Access Compliance Report

Public Rights-of-Way

Intersection ID: 21435	Main Street: SARDIS_LN	Cross Street: DUNEDIN_LN	Location: NE
ADA ID: 4F973C808648	Ramp Type: Directional1	Initial Pass/Fail: Fail	Overall Compliance: No
		Severity Score: 1.25

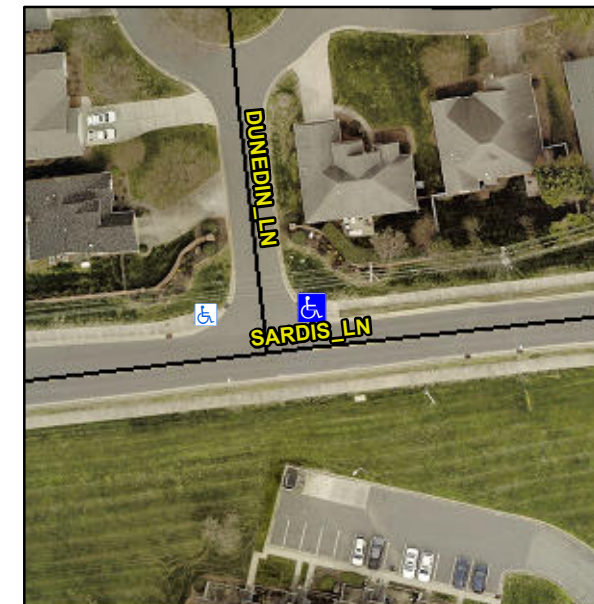
R304.5.3

Remove & Replace Entire Ramp.
